**MODIFICATION REQUEST:
Sydney Adventist Hospital
Lot 621 DP 1128314,
Fox Valley Road, Wahroonga.
(MP10_0070 MOD1)**

Director-General's
Environmental Assessment Report
Section 75W of the
Environmental Planning and Assessment Act 1979

December 2011

Figure 5: Proposed multi-deck car park

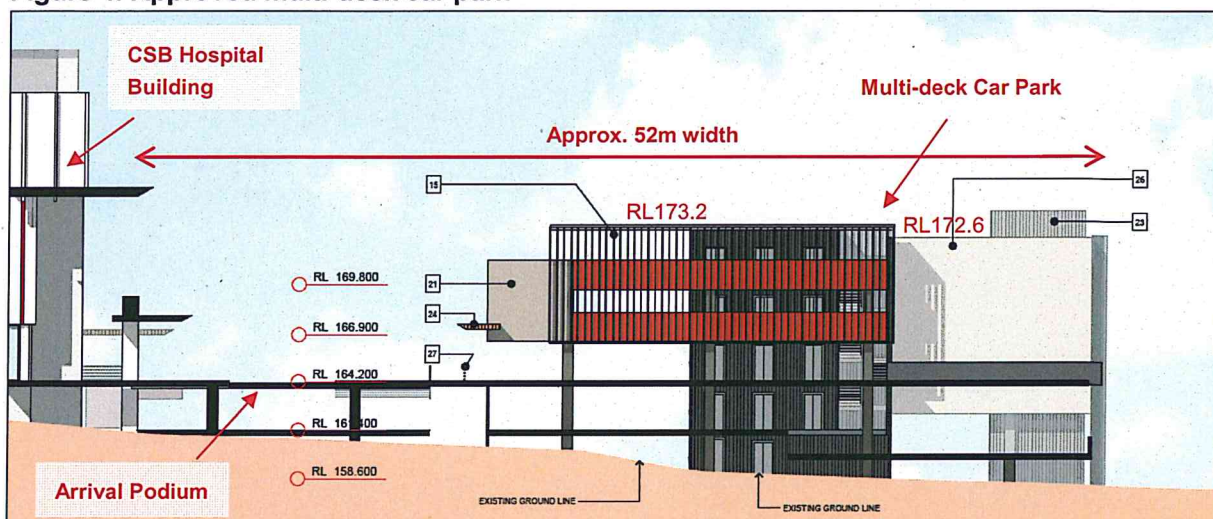
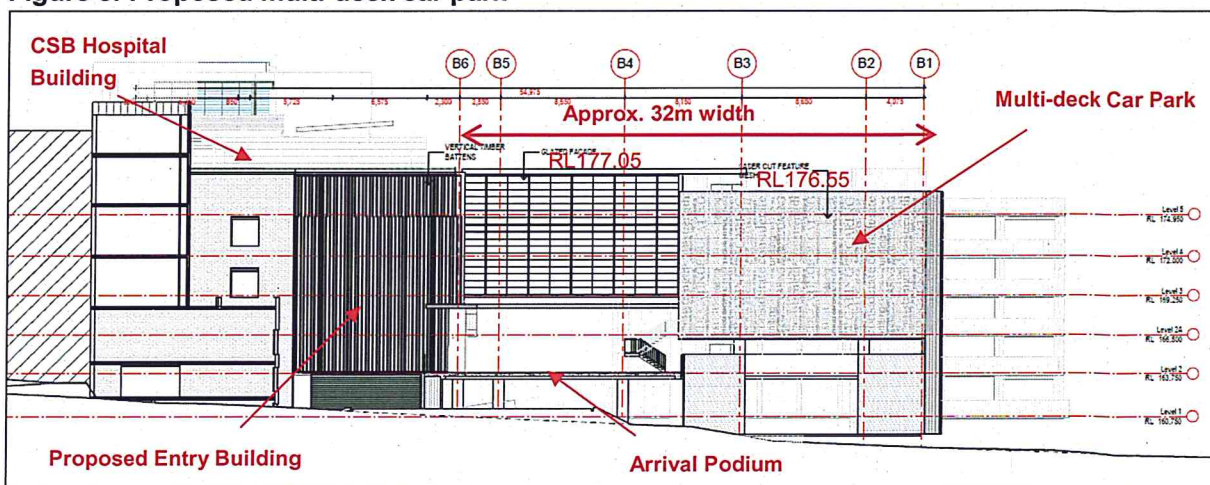
The proposed modifications to the multi-deck car park seek to combine the approved 5/6 split-level car parking structure and 2 level arrival podium together and integrate car parking and patient drop-off into a single 6 level structure. As can be seen in Figures 4 and 5 below, the multi-deck car park was separated from the rear of the CSB hospital building in the approved design by the arrival podium. In the amended design, the podium is integrated into the car park.

As a consequence the height of the modified structure will increase by only 0.2m and the width of the approved multi-deck car park and arrival podium is reduced from approximately 52m to a combined width of approximately 32m (see Figures 4 and 5). It should be noted, however, that the structure's overall maximum height (RL177.05) will be approximately 4m higher than the approved maximum height (RL173.2) as less excavation is proposed in the construction of the modified multi-deck car park.

Council raised concerns that the relocation and approximate 4m relative height increase would result in a substantial increases to the bulk and scale of the car parking structure. The department acknowledges that the approved eastern and western elevations would have provided a greater sense of separation from hospital. However, the bulk and scale of the approved design would still have been evident from these locations. The proposed amendments shift the built form closer to the hospital, but retain a similar bulk and scale that is better integrated into the hospital campus and its associated functions.

Furthermore and as outlined above, the increase in height to the actual structure is only 0.2m and the proposed height increase in the context of the approved future built form of the CSB expansion, approximately 26m higher, is not considered to be significant.

While the proposed amendments to the multi-deck car park reposition the built form of the car parking structure closer to hospital buildings, the department is satisfied that the proposed amendments would not detrimentally add to the bulk and scale of the hospital redevelopment, but rather help to integrate the structure into the expanded CSB building and consequently provide a greater setback to the existing bushfire prone land at the rear. The development is largely contained within the existing SAH campus footprint, with the existing bushland reserve behind the property screening much of the hospital's built form from surrounding residential areas to the north of the subject site. The department raises no objection to the amendments to the multi-deck car park and considers the design modifications satisfactory.

Figure 7: Proposed Multi-Deck Car Park – Level 2

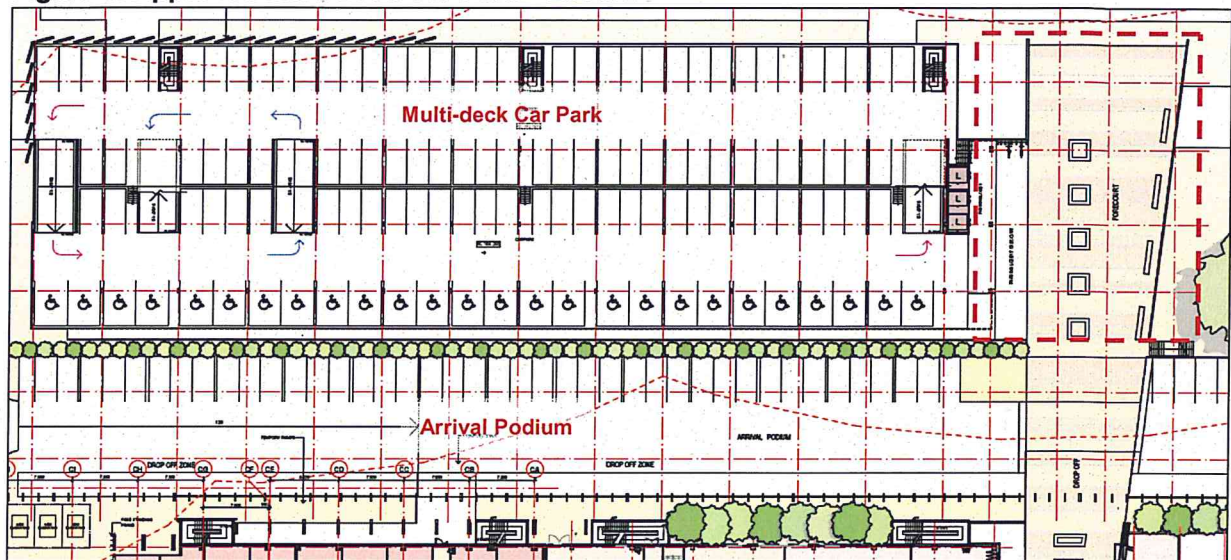
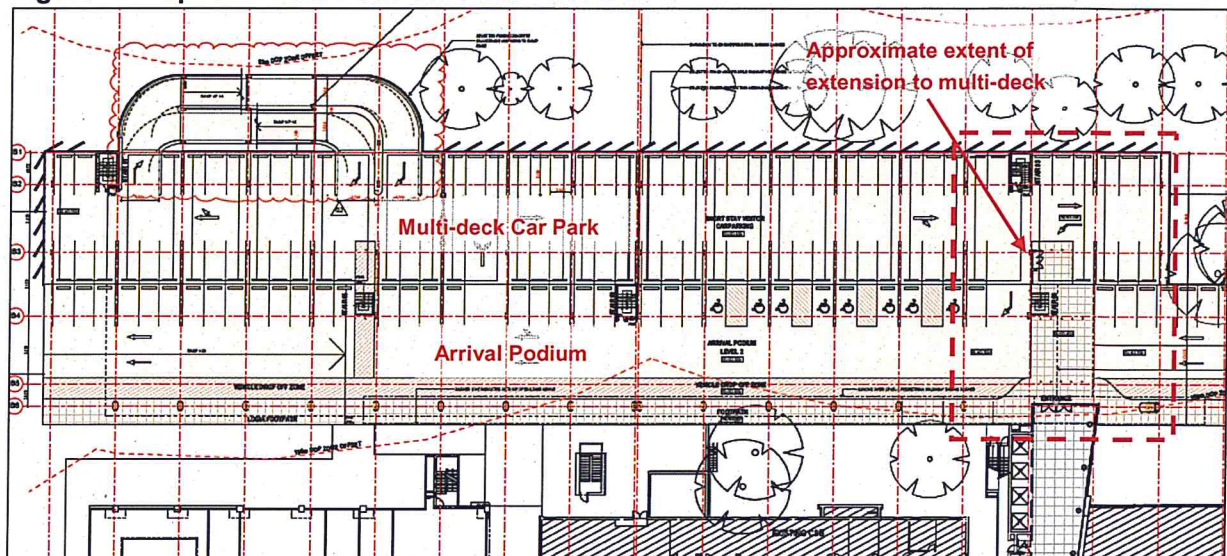
The amended design reduces the separation of the car parking structure from the adjacent CSB and SAN Clinic hospital buildings from 18m to 12m. The setback of the multi-deck car park to the bushfire prone vegetation at the rear of the site will also be increased to outside of the 50m defendable space, thereby reducing the structure's exposure in the event of a bushfire. The length of the car parking structure is

increased by approximately 30m, projecting just beyond the existing walkway between the CSB and SAN Clinic building (see Figures 6 and 7).

The revised location of the multi-deck car park will provide increased opportunities for landscaping and tree retention within the separation between the multi-deck car park and existing hospital buildings, as confirmed by the proponent. Accordingly, a new condition is recommended requiring an amended landscaping plan be submitted to the department prior to the issue of the construction certificate for the multi-deck car park, detailing revised landscaping and trees proposed to be retained.

Figure 8: Proposed Entry Building

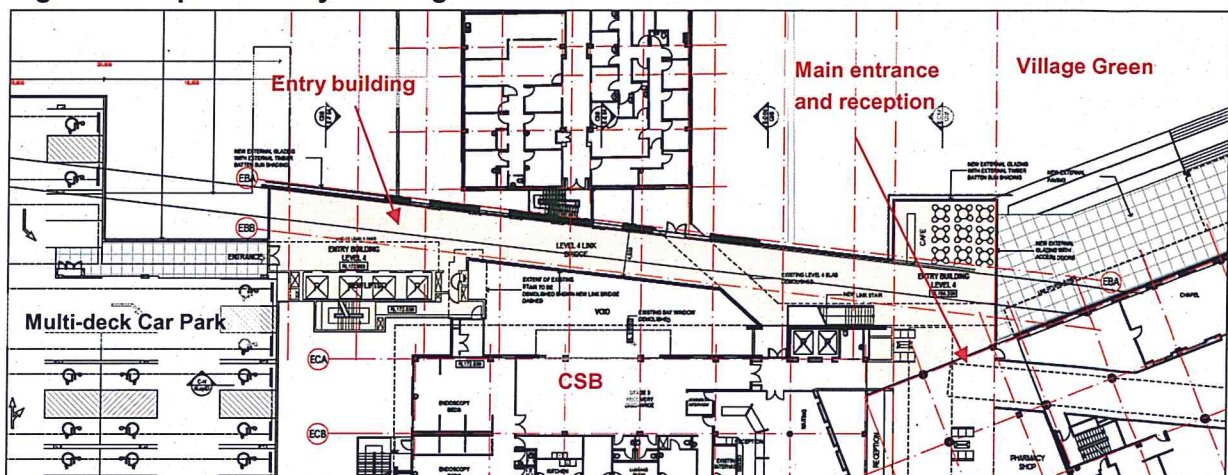
The new entry building, which encompasses 4 lifts, is proposed to provide improved pedestrian access for patients, visitors and staff, directly from each level of the multi-deck car park into the CSB hospital building adjacent. The entry building will also provide a direct linkage from Level 4 through to the existing main hospital entry and patient admissions area of the Clifford Building and Village Green (see Figure 8).

Council raised concerns that the proposed amendments do not enhance the quality of the main hospital entry, however, the proponent has stated that the former concourse or current proposed design of the entry building were never intended to be the "main entry" of the hospital. Architecturally, the main hospital entry was and remains at the front of the hospital site, in the Clifford Building on Level 4 and oriented to the Village Green.

The proposed entry building lift core will require the relocation of bicycle parking, approved at Level 1 adjacent to the approved medical records room. Accordingly, a new condition is recommended requiring details to be provided to the department showing a suitable revised bicycle parking/storage location of similar size and capacity, prior to the issue of the construction certificate for the entry building works.

The department raises no objections to the form and intended function of the proposed entry building. The integration of the structure with the amended multi-deck car park will provide direct pedestrian access from the patient/visitor car parking facility to the hospital. The entry building will provide sheltered and comfortable access to the hospital, linking patients and visitors to the main hospital entry/reception and new café space on Level 4, overlooking the Village Green.

Figure 9: View Retention – Entry Building Level 4

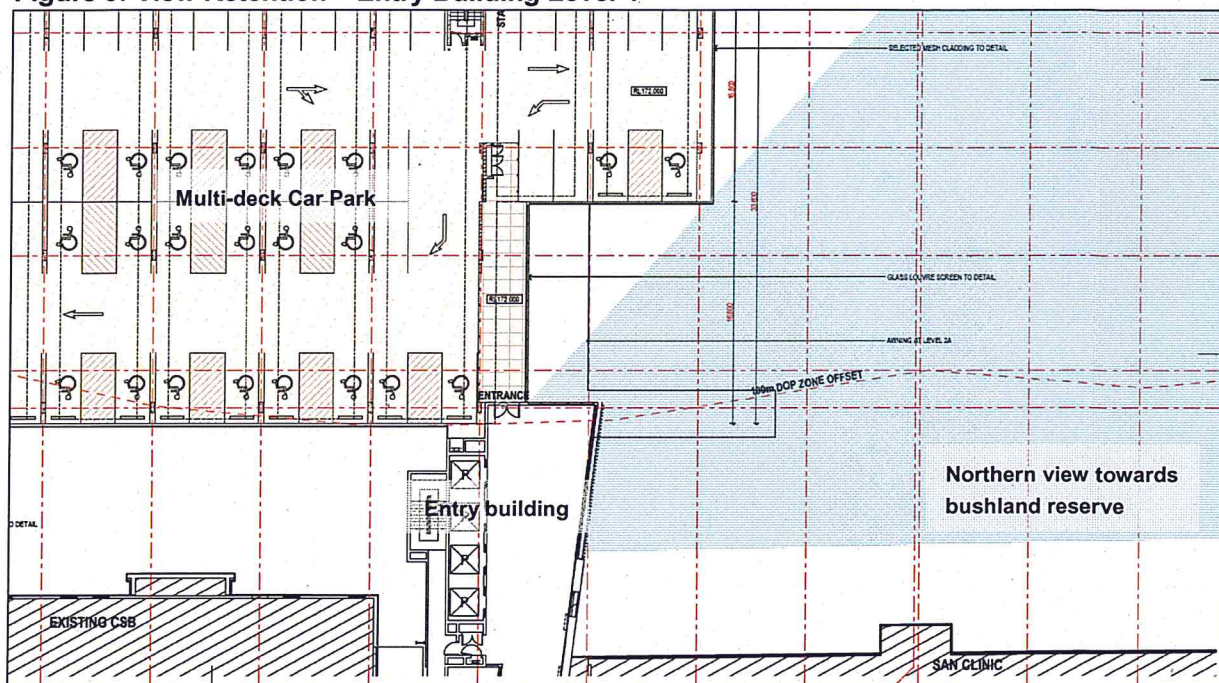
Council raised concerns regarding the impact the proposed design amendments to the multi-deck car park and entry building would have on the amenity of the hospital entry, sense of arrival, adjoining hospital buildings, namely the CSB and SAN Clinic Building, landscaping opportunities and on the visual outlook to the bushland reserve at the rear of the hospital site.

As noted by the proponent, the main hospital entry will remain at the front of the hospital site, overlooking the Village Green. The new hospital entry at the rear of the site, as approved, was designed to create a more pleasing and functional entrance for patients and visitors arriving by car and improve access to the main hospital buildings. This is retained within the proposed amended design. External glazing is proposed for the exterior of the entry building, offering visitors and patients views of the bushland reserve to the north of the site (see Figure 9).

The minor increase in height of the amended multi-deck car park design will not result in a significant impact on the existing bushland reserve outlook from the existing or proposed hospital buildings adjacent. Views to the bushland are retained from Level 5 and above, while the original approved multi-deck car park would have provided Level 4 with partial views towards the rear of the site. The loss of views from Level 4 is not considered detrimental to the future operation and functions of the hospital, with only endoscopy and day surgery medical procedures undertaken on Level 4 of the CSB adjacent. Importantly, views from the future hospital wards within the CSB expansion development will remain unobstructed.

The department considers the amendments to the design of the multi-deck car park and entry building will not detrimentally impact on the amenity of the hospital. Appropriate conditions are recommended to ensure additional landscaping is achieved within the building separation areas.
